Integrated Services Digital Network (ISDN); Basic user-network interface Layer 1
specification and test principles

**ETS 300 012**

**A1**

**This amendment A1 modifies
the European Telecommunication Standard ETS 300 012 (1992)**

**Figure 3: Power start up test for TE**

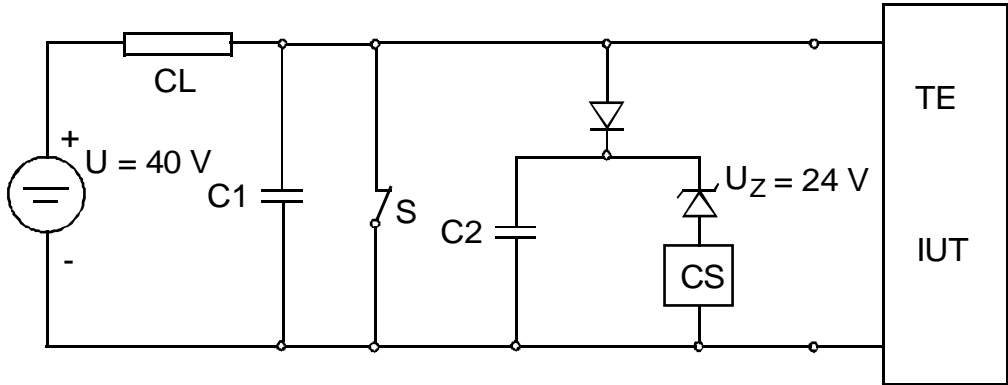
### Page 18, figure 3

Replace figure 3 with the following figure:

**Figure 7: Test circuit for applied current unbalance**

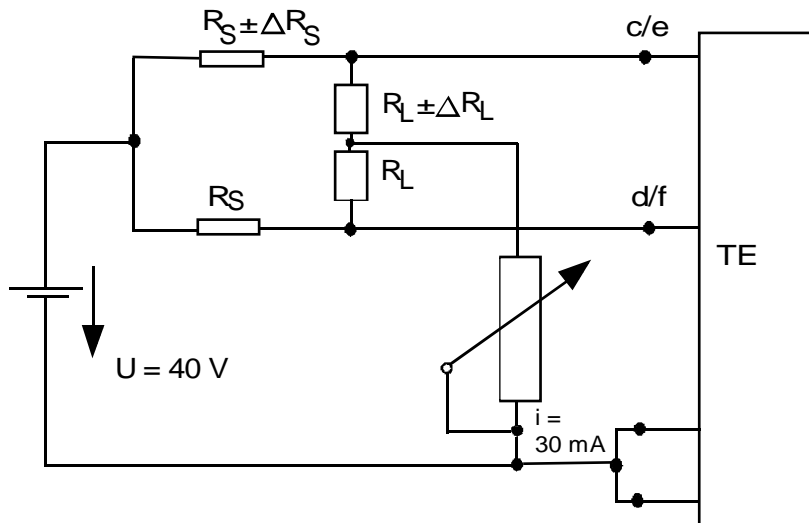
### Page 22, figure 7

Replace figure 7 with the following figure:

| $R_S = 6\ \Omega$ | $\triangle R_S = 360\ m\Omega$ |
| $R_L = 5\ \Omega$ | $\triangle R_L = 300\ m\Omega$ |

$$X = \frac{\triangle R_S}{2 R_S} = \frac{\triangle R_L}{2 R_L}$$
